PINS reference: EN020026

Application by National Grid Electricity Transmission plc (“the Applicant”) for an Order granting Development Consent for the Sea Link Project

Applicant’s Response to Request for Information dated 9 October 2026 and Further Comments from the Applicant

Figure showing Offshore Scheme (red) and subtidal chalk habitat (green)

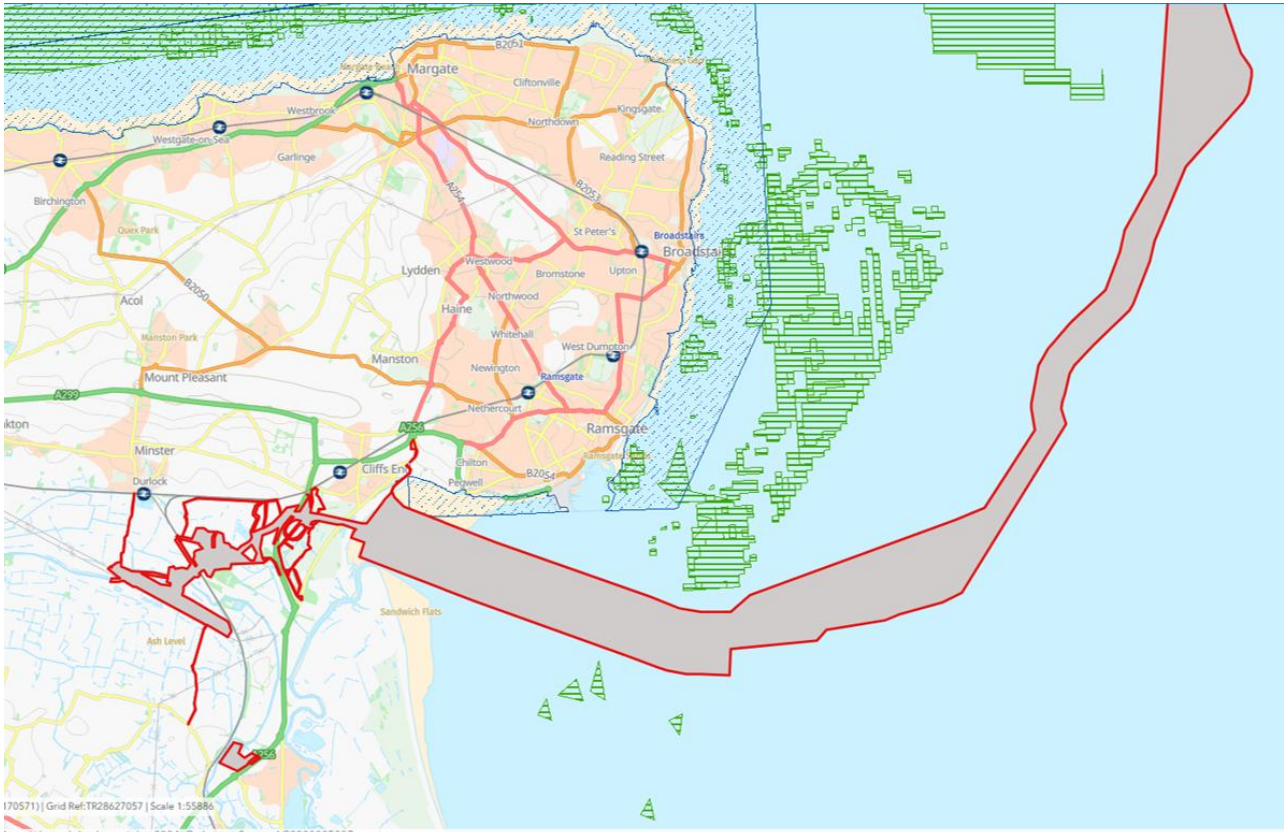
Paragraph 5	Chalk habitat	The Applicant refers KWT to C1-178 Responses to Secretary of State's Consultation 1 – 9.158. The habitat referred to in Application Document 6.2.4.2 Environmental Statement Part 4 Marine Chapter 2 Benthic Ecology [REP7-099] is Subtidal chalk (covered by the sea at all times) and is not included in the NPS EN-1 list. As recognised by KWT, the Marine Irreplaceable Habitat (MIH) definition and scoring system used in this report does not define a legal threshold or statutory designation but provides further evidence to highlight areas where restoration is most likely to be very difficult, slow, or unfeasible. As outlined in the 2023 report by Natural England, this MIH work is not statutory guidance and not policy. It is also currently independent from terrestrial Irreplaceable Habitats statutory guidance which the 2023 NPS EN1 paragraph 5.4.53 refers to. Therefore, as the term 'irreplaceable' used in the marine chapters is based on the 2023 Natural England report for marine habitats and not NPS EN-1, paragraph 5.4.53 is not relevant in this instance. The MIH definition and scores in the 2023 report are used to inform strategic planning decisions only and has been referenced within REP7-099 following discussions with Natural England. The assessment conclusions within REP7-099 for subtidal chalk remain minor. The area of subtidal chalk offshore mapped within the cable corridor during baseline surveys was estimated to be less than 250 m² and is completely outside of any type of designated or protected sites. A figure of the Offshore Scheme overlaid on the spatial distribution of subtidal chalk reef habitats was submitted during the Examination Phase, in response to a question on this issue from Natural England, which can be found in Application Document 9.86 Applicant's Comments on Other Submissions Received at Deadlines 3 and 3A [REP4-241]. The habitat mapping from the Water Framework Directive (WFD) High Sensitivity Habitat data layer on magic.gov.uk shows the very significant extent of this habitat and its avoidance by the Offshore Scheme. For clarity a copy of this figure is also provided below. However, this habitat was given a high sensitivity rating in the assessment, on a precautionary basis, despite the offshore baseline surveys providing no evidence that this area of habitat supports biological communities to indicate these were high-quality examples, particularly as much of the chalk was found to be below the surface. Due to the localised nature of installation activities and the small-scale installation footprint compared to the much wider available area of subtidal chalk habitat in the Southern North Sea, that is protected by both Special Area of Conservation (SAC)

and Marine Conservation Zones (MCZ) designations on the Thanet Coast (avoided by the Proposed Project), the physical disturbance, and hence permanent loss, to this habitat, it is predicted to be of small magnitude and not significant.

Appendix A : Approval of amendments to the Scottish Power Renewables Landscape Masterplan under the East Anglia ONE North and East Anglia TWO DCOs

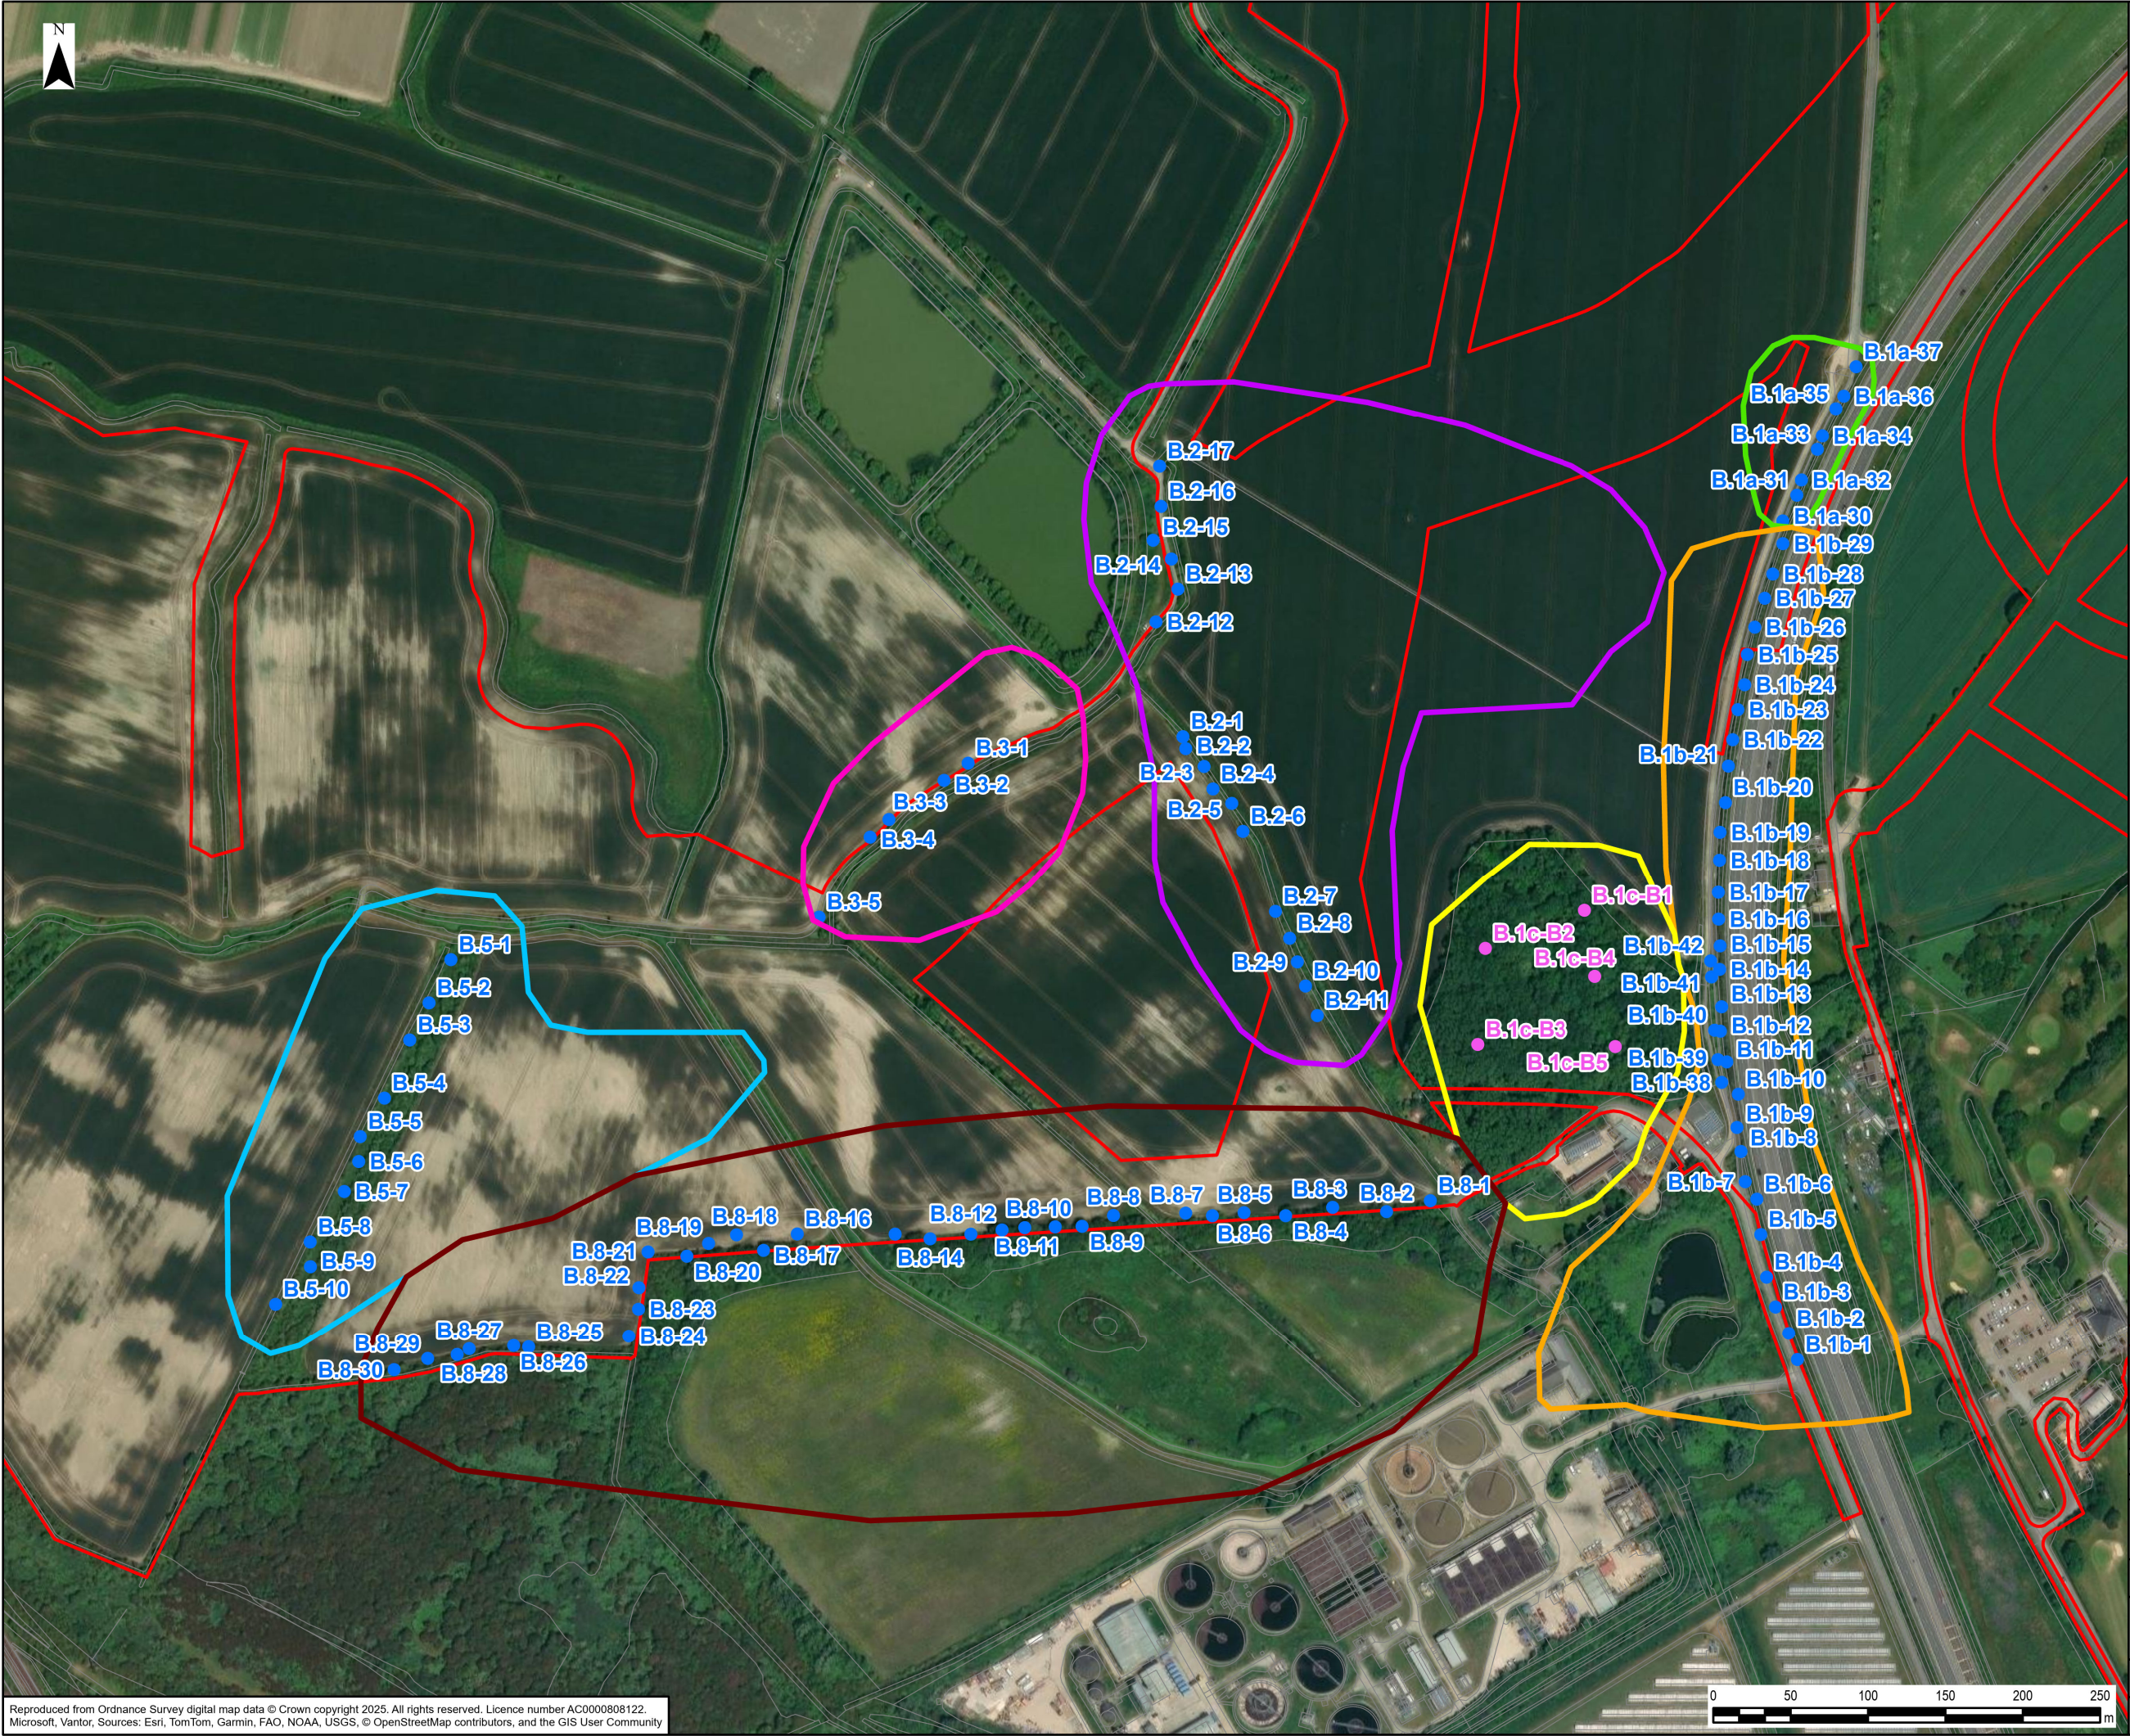
Discharge of Requirement 40 (Amendments to approved details - Amendment to Approved Landscape Masterplan) Substations Stage of East Anglia ONE North and East Anglia TWO Offshore Wind Farm Development Consent Orders

The details given within the application (DC/26/2999/DRR and DC/26/3000/DRR) received 23 August 2026 in respect of Requirement 40 to amend the specified approved details of the East Anglia ONE North and East Anglia TWO Offshore Wind Farm Development Consent Orders are acceptable. Subject to works being carried out in accordance with the approved amended details, Requirement 40 will have been complied with to the local planning authority's satisfaction.

Appendix B Distribution of dormouse survey tubes in Kent

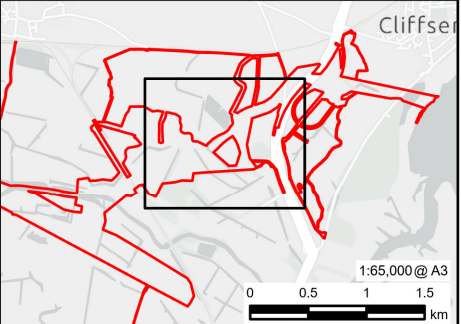
Response from	Paragraph number from SoS letter dated 28 August & reference number	Topic Summary	Applicant's Response
			<i>“The score provided for Zone D of the survey area is 14.96, below the threshold at which likely absence can be concluded. Therefore, these surveys cannot reliably be used to support a conclusion of likely absence”.</i> <u>Applicant’s Response:</u> This area of habitat is poorly connected (including no connectivity to the rest of the Kent Onshore Scheme due to the presence of the River Stour that acts as a barrier to movement), and none of the suitable habitat in this zone will be lost. This area adjacent to the Stour is a flood plain and floods extensively in the winter making it unsuitable for hibernating dormice; however, it was surveyed in 2023 to 2024 for completeness. The score of 14.96 is therefore not considered to be a constraint when considering required mitigation. <u>NE’s Comment (Kent):</u> <i>“The score for Zone B does exceed the 20 threshold; however, it is not clear from the figures how well connected the habitat between the subsections of Zone B is. The Handbook (second edition) recommends that at least 50 tubes are used per survey and highlights the risk of missing dormouse presence when small numbers of tubes are used. Surveys in Zone B3 used only 5 nest tubes, and B4 used 10. Without further detail from the applicant on the connectivity between these subsections, and the justification for the numbers of nest tubes used, it is difficult to determine the acceptability of Zone B survey methodology”.</i> <u>Applicant’s Response:</u> An individual zone represents an area of connected suitable habitat for the purposes of determining the survey score in line with the 2006 Guidelines. The sub zones reflect land parcels, within each Zone and are relevant to the score as different land parcels within a Zone may be accessed on different dates or have differing restrictions. All of the subzones in Zone B are connected, so considered as a single collective area for the purpose of the calculation, based on between 96 and 104 nest tubes checked on four occasions, covering the months of August, September, October and November 2023 and April, May, June and July 2024. An updated Figure is provided in Appendix B which shows the Zone B nest tubes plotted on aerial background mapping, with the connectivity between the different subzones visible, for clarity. <u>NE’s Comment:</u> <i>“Natural England notes that there have been past dormouse records close to the scheme footprint, resulting in the issuing of a dormouse mitigation licence in 2017 (Magic Map (MAGIC)) west of the A256, confirming dormouse presence in this area. There appears to have been potential dormouse nests discovered as part of the Scheme survey effort, which were subsequently discounted from further survey effort. We are of the view that residual risk around the presence of dormice remains which the applicant has not sufficiently addressed. Natural England, therefore, agrees with the Applicant's comments in Section 1.5.6 of APP-159 that further survey effort is needed, and indeed, we would encourage such further survey prior to construction, and should those surveys identify presence of dormice a dormouse mitigation licence is likely to be required”.</i> <u>Applicant’s Response:</u> The Applicant notes that the protected species mitigation licence (EPSML 2015-16799-EPS-NSIP2-1) first listed in 2015 with two subsequent updates is located approximately: • 1km from Zone A at its closest point, however this is separated by the barrier of the A256 dual carriageway. • 1.1km from Zone B at its closest point. There is connectivity to Zone B habitats. • 1.4 km from Zone C at its closest point, on the opposite side of a railway line. • 1.1km from Zone D, separated by the barrier of the River Stour in addition to the railway line.
